Elite Garments Ind. Ltd.

Bade Kalmeswer, Board Bazar, Gazipur, Bangladesh
(23.954199, 90.380240)

5th April 2014
8th April 2015

Observations Made

Steel Roof Sections – Building 4

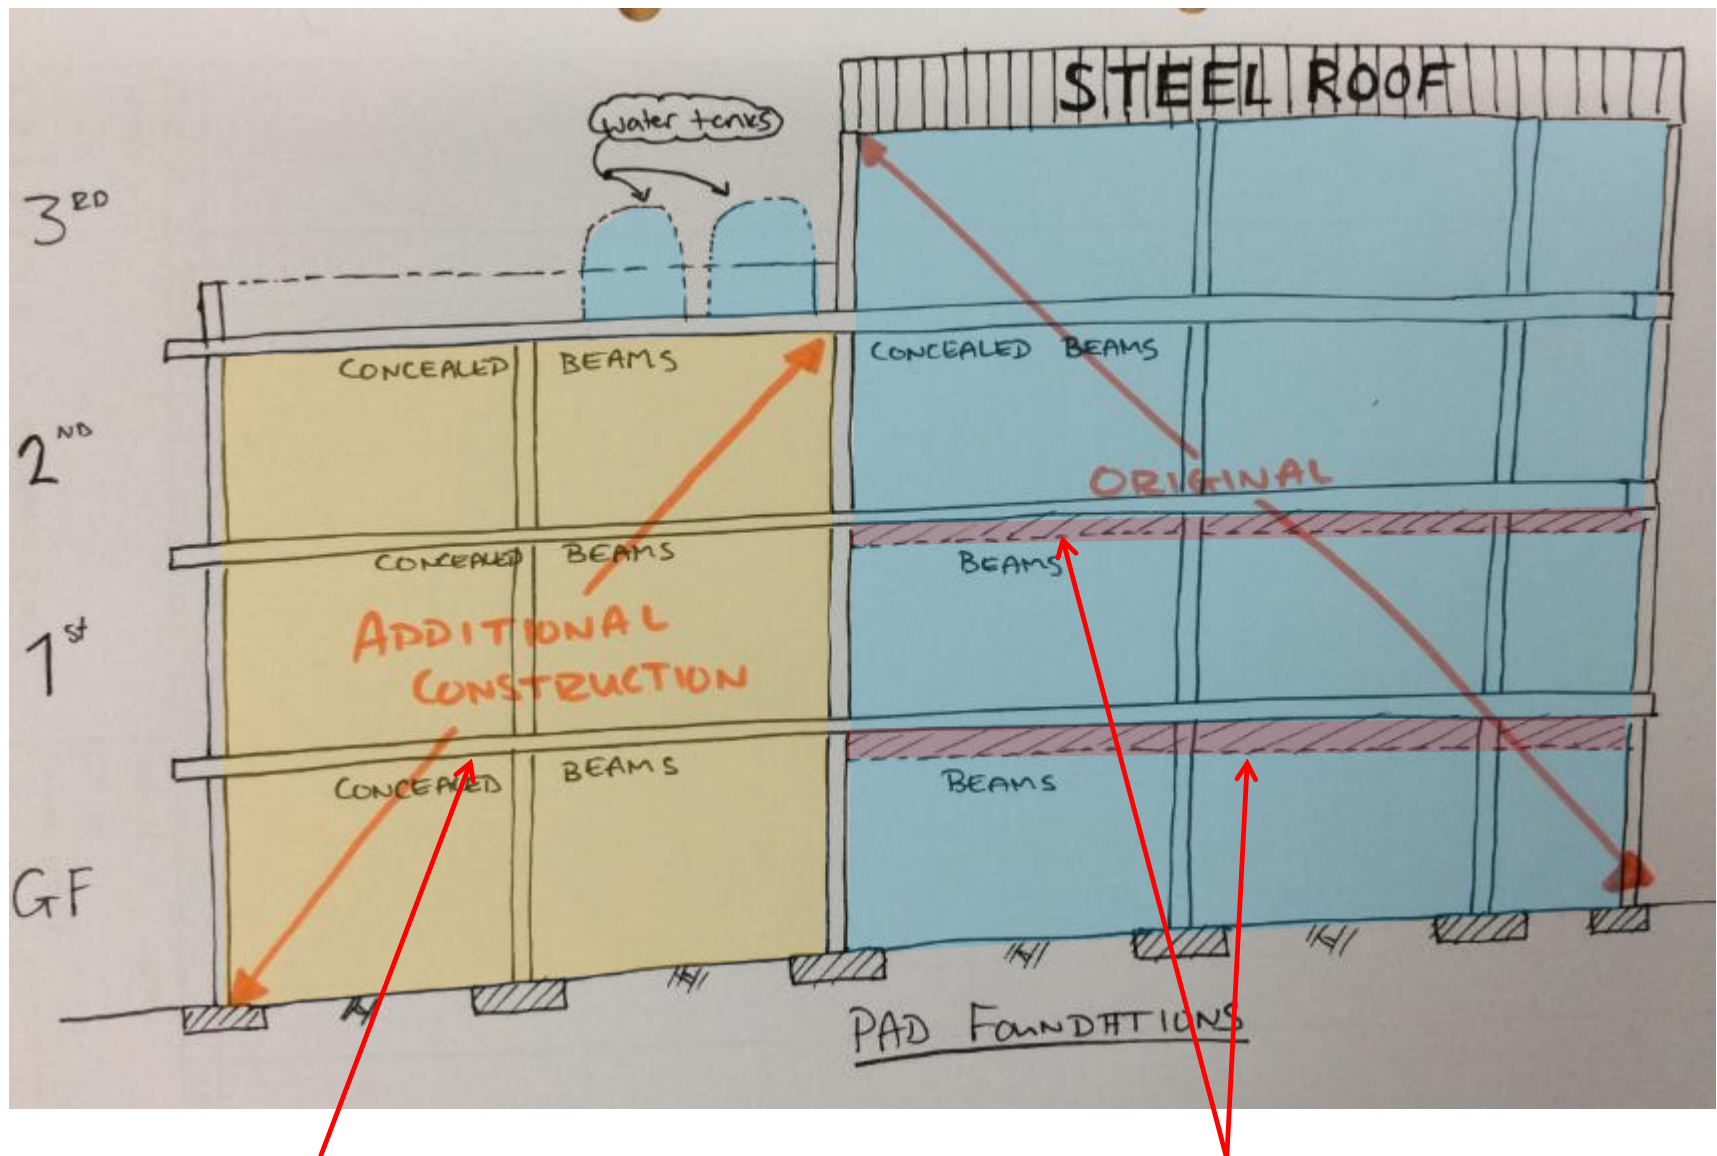
Steel roof over 4 storey section of Building 4.

Central Truss Section does not sit directly onto column below.

Steel Roof connections in Building 4 appear inadequate to resist high wind loading and should be checked by a Building Engineer.

Beams and Slab on underside of 1st and 2nd Floors

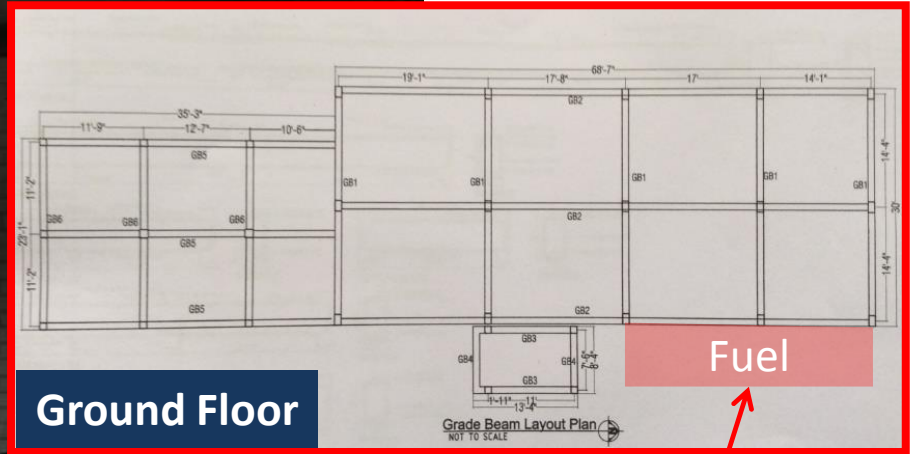
With the new portion of the Building Constructed, and no apparent beams on some levels, that Lateral stability system of Building 4 should be checked by a Building Engineer.

Building N7

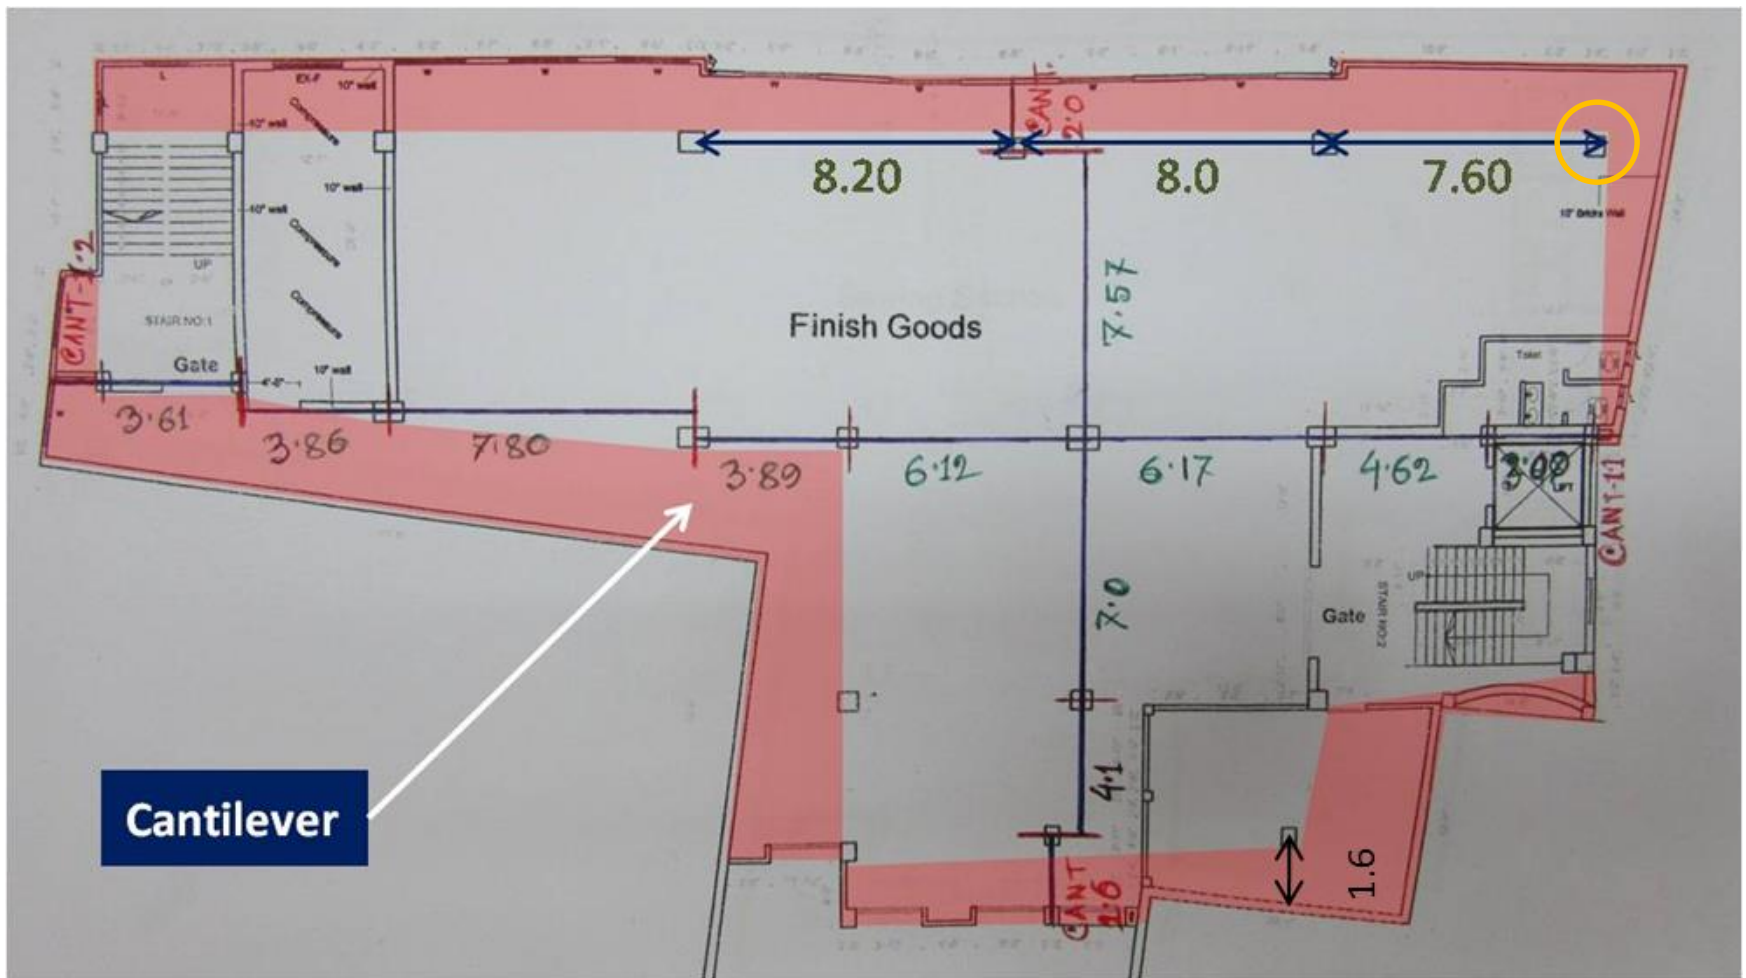
Apparently high stressed column

Cursory result shows high stress in the highlighted column due to heavy load coming from toilet present on different floors and water tank on roof top.

Apparently poor construction joints between buildings

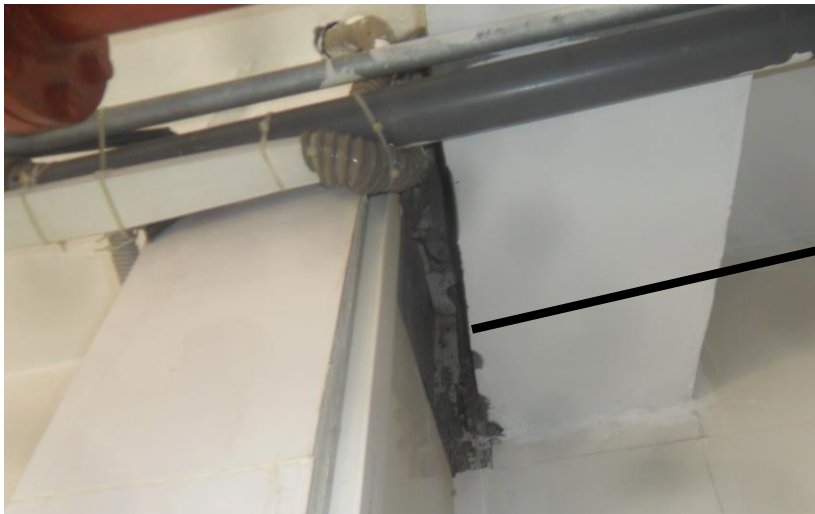
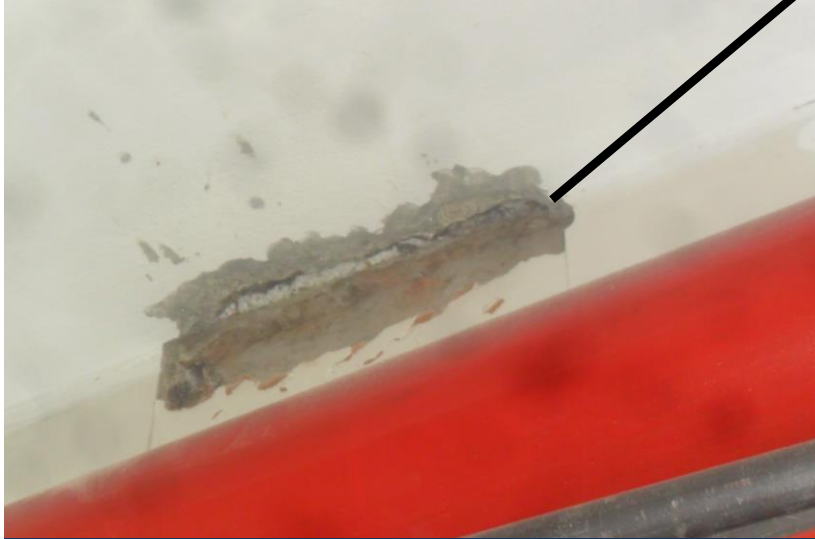
The construction joints between B7 and B1 and B3 is not apparent. In some places there are small construction joints and in other places the structural elements look connected. The façade walls of B1 and B3 are used as a common wall with B7.

Construction joints are not clearly observed between inspected building and building - 2

Construction joints observed between inspected building and building - 3

Apparently heavy loaded areas

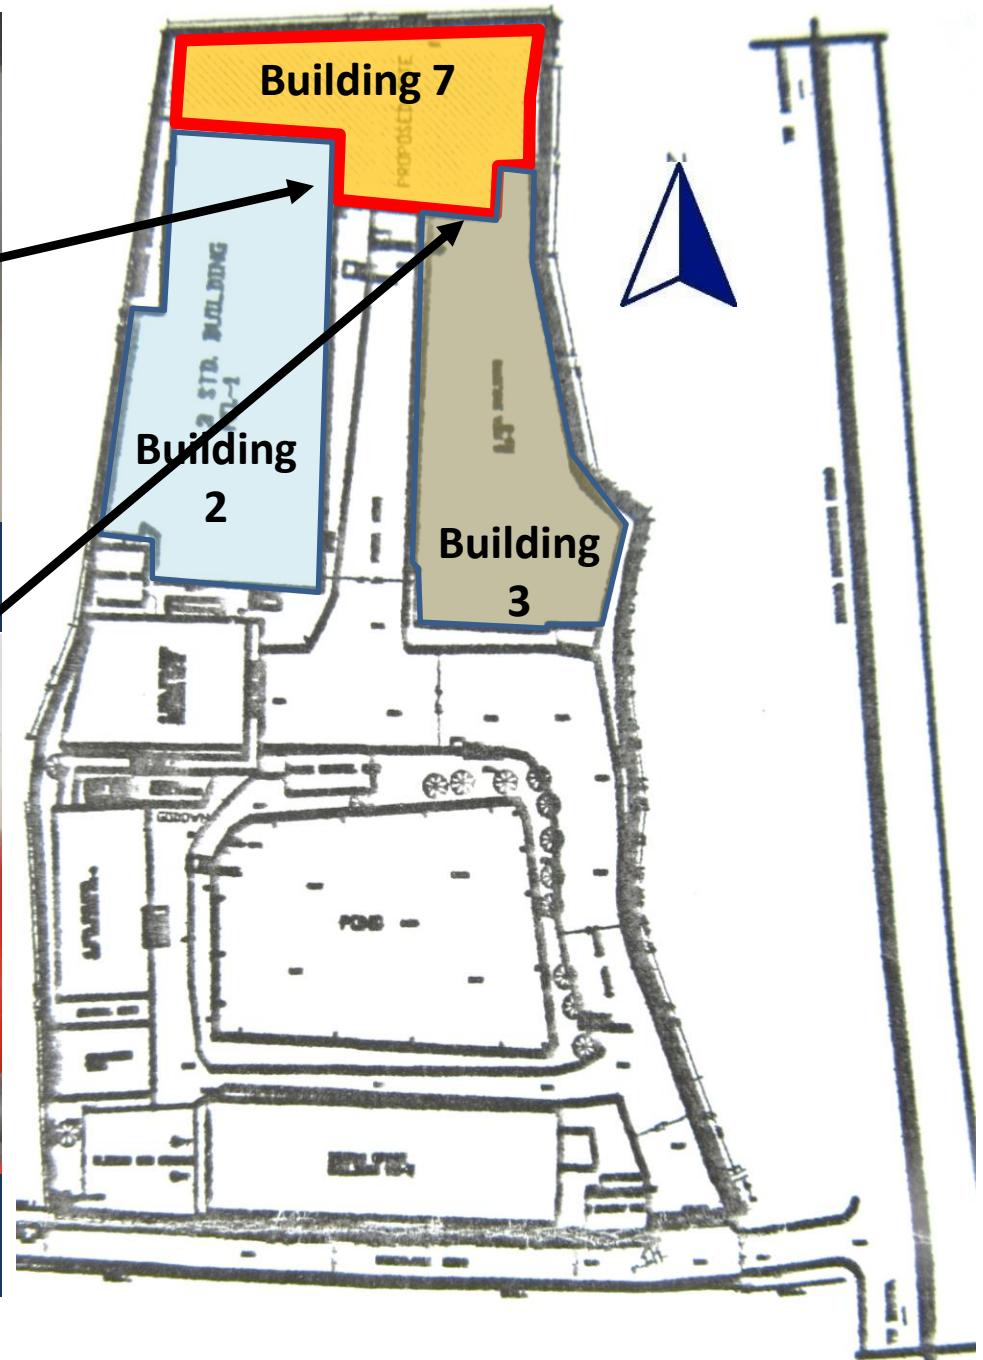
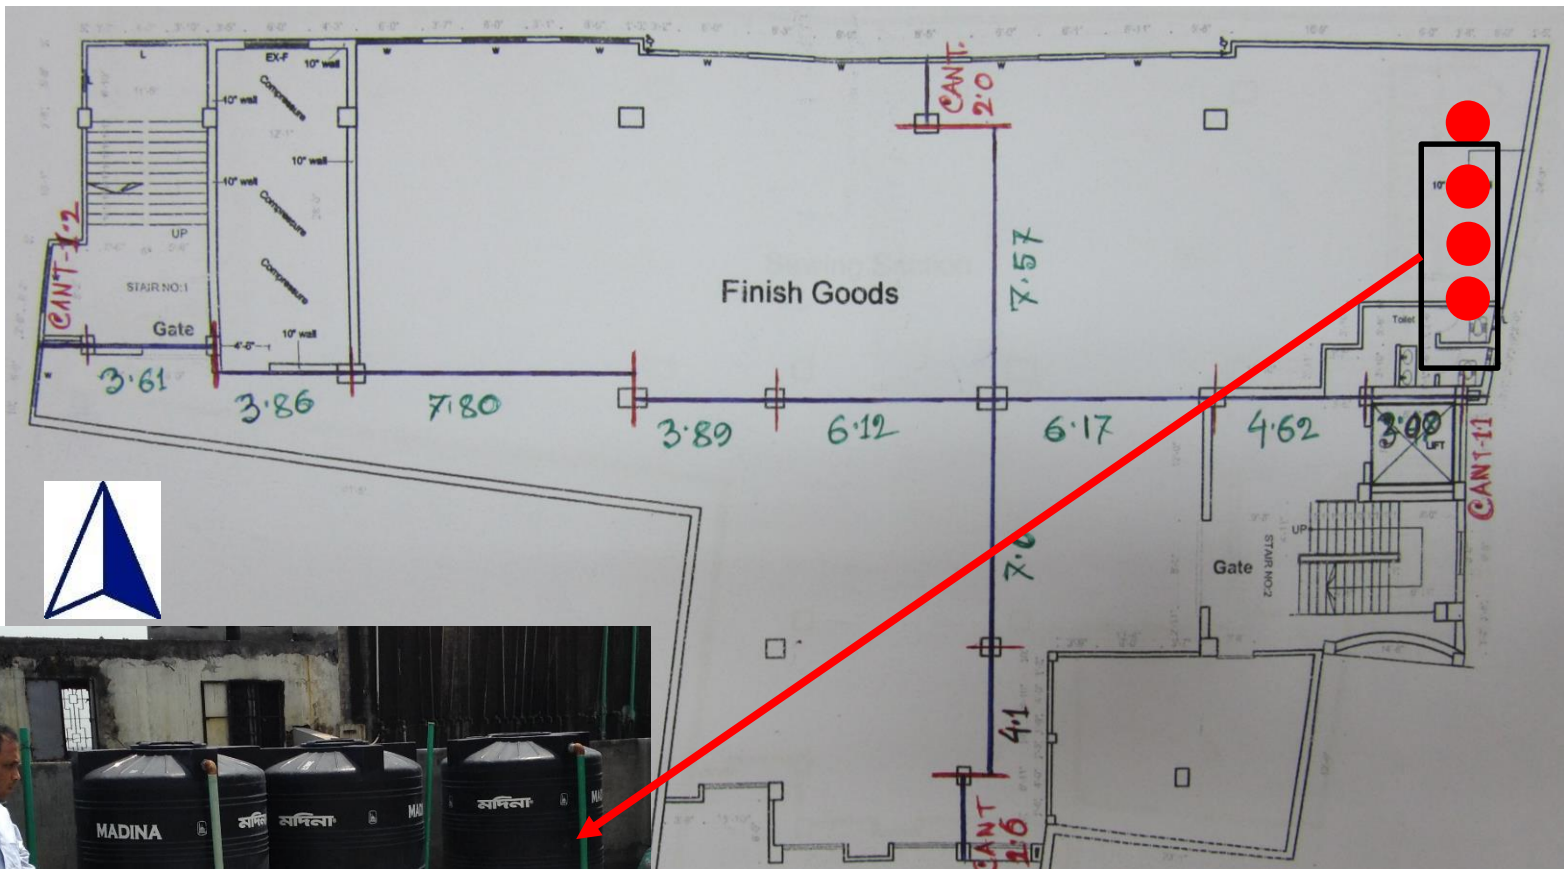
Apparently high loading in the toilet area

Heavy loading observed on 1st floor
